Proposed Site Layout Plan 1:200

Architectural and Surveying Services
ShanRye
 Kevin Watts BSc.
 Building Surveyor and Architectural Technician
 24 Sandgalls Drive, Lakenheath, Suffolk, IP27 9EG.
 Tel: 01842 862445. Mobile: 07876 310614.
 kevin@shanrye.co.uk www.shanrye.co.uk
 A friendly, professional service at a very competitive price.
 Client
Mr.M.Jamieson
 Site
49 High Street, Lakenheath, Suffolk.
 Project
Proposed Conversion and Extension of Outbuilding into 2no. Dwellings
 Drawing
Proposed Floor Plans, Elevations, Section, Site Layout and 3Ds
 Drawing Size A1 Scale(s) 1:200, 1:50, 1:75
 Date March 2022 Drawing no. 388/2/03/J

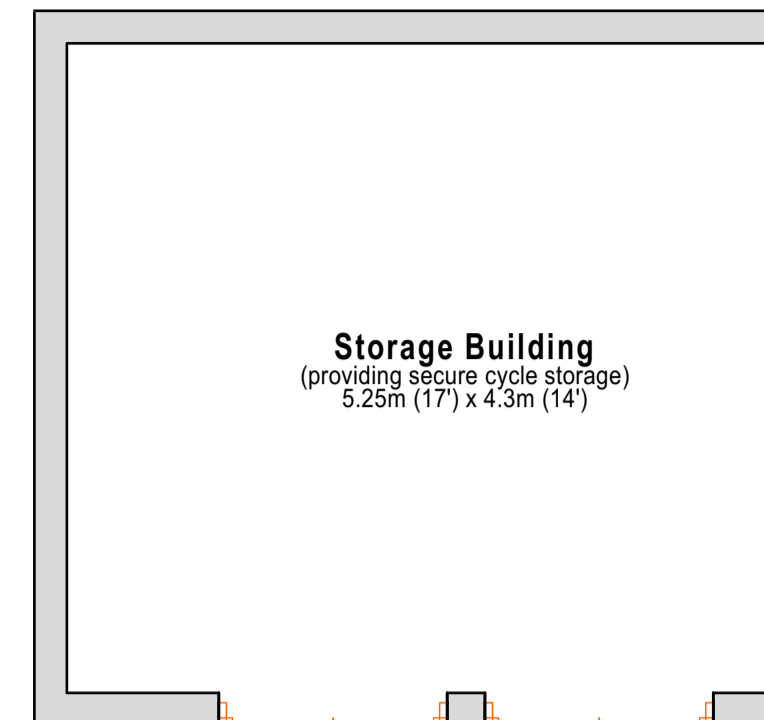
Rev.J / 26.09.23 / krw
 Amended as per client requests, as follows:
 - Double doors to Storage Building.
 - Cycle hoops added.
 Rev.H / 14.09.23 / krw
 Amended as per client requests, as follows:

- Main Entrance roof slates
 - Single doors, plus windows, to front of external store.
 - Utility amended.
 - Kitchen / Dining door made double, with windows reduced.

- Kitchen / Dining rooflights reduced from 4no. to 3no.
 - First floor bedrooms made same size
 - Swift boxes added to 2no. gables.
 - 2no. hedgehog gaps added in fencing.

- External Works Annotation added.
 - External Storage used for secure cycle storage.
 Rev.G / 11.09.23 / krw
 Amended as per client requests, as follows:

- Lounge amended to external storage.
 - Bathroom and ground floor bedroom omitted in favour of lounge and drawing room.
 - Link amended to entrance hall, with cloaks + shower.
 Front wall amended from glass to horizontal timber boarding.
 Roof amended from glass to black corrugated PPO aluminium.
 Wet room moved into entrance hall, laundry lengthened.

- First floor w.c. amended to bathroom, with stairs amended to accommodate.
 Rev.F / 22.11.22 / krw
 1m taken off width of extension.
 All rooflights facing church / South omitted.
 Double stemmed tree shown to be removed.
 Rev.E / 22.09.22 / krw
 Layout amended further to client meeting
 Rev.D / 19.09.22 / krw
 Amended to address CPO concerns, including:

- reduction from 2no. to 1no. dwelling.
 - increase in amenity area.
 - reduction in overall footprint.
 Rev.C / 06.04.22 / krw
 Rear gardens of nos. 51, 53 & 55 indicated.
 Rev.B / 01.04.22 / krw
 Amended further to client meeting.
 Rev.A / 27.03.22 / krw
 Amended further to client meeting.
